Inspection Photos

ID: 442224

Operator: OXY USA INC

COLORADO
Oil & Gas Conservation
Commission

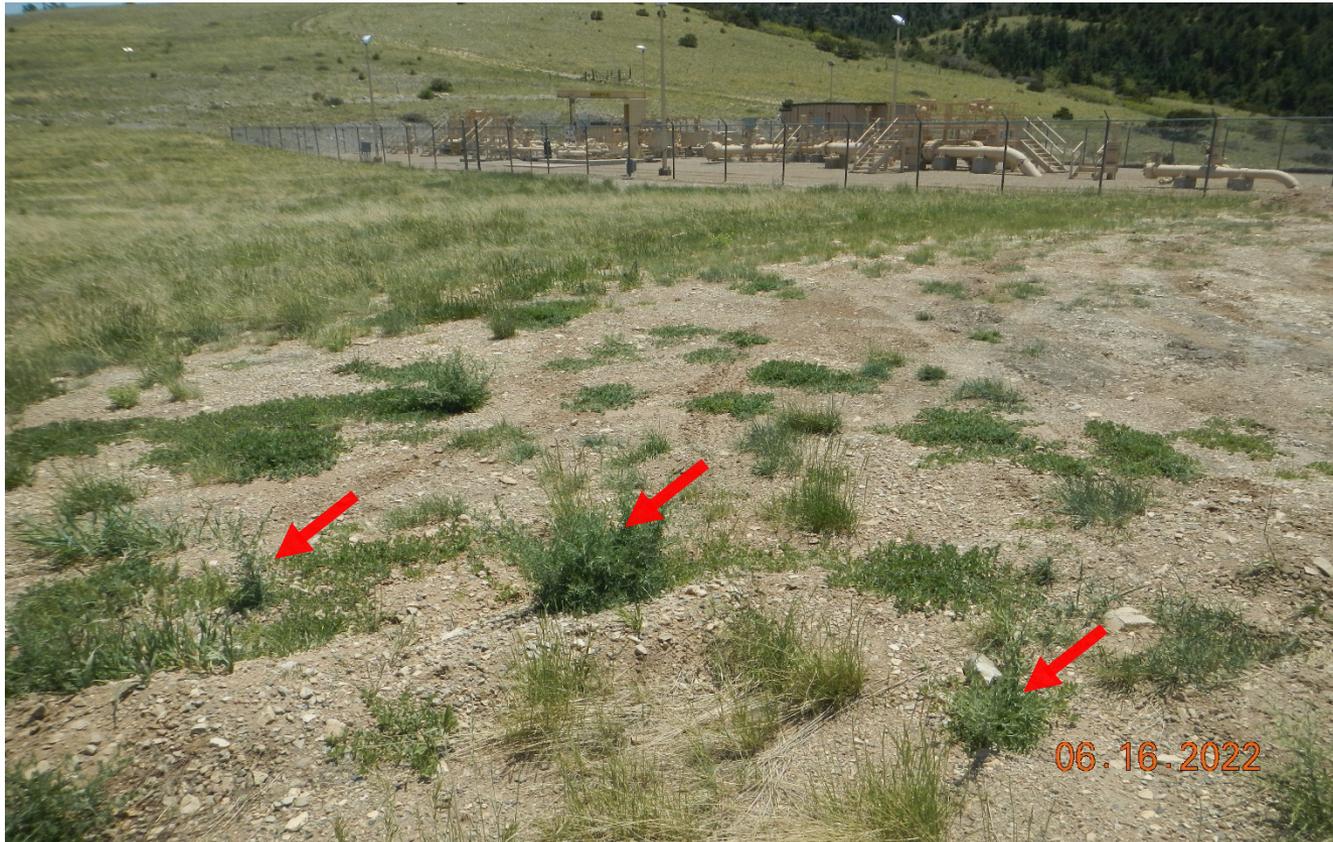
Photo 11. Facing southeast toward the meter station. Diffuse knapweeds is shown at red arrows and needs to be controlled soon to prevent seed dispersal.
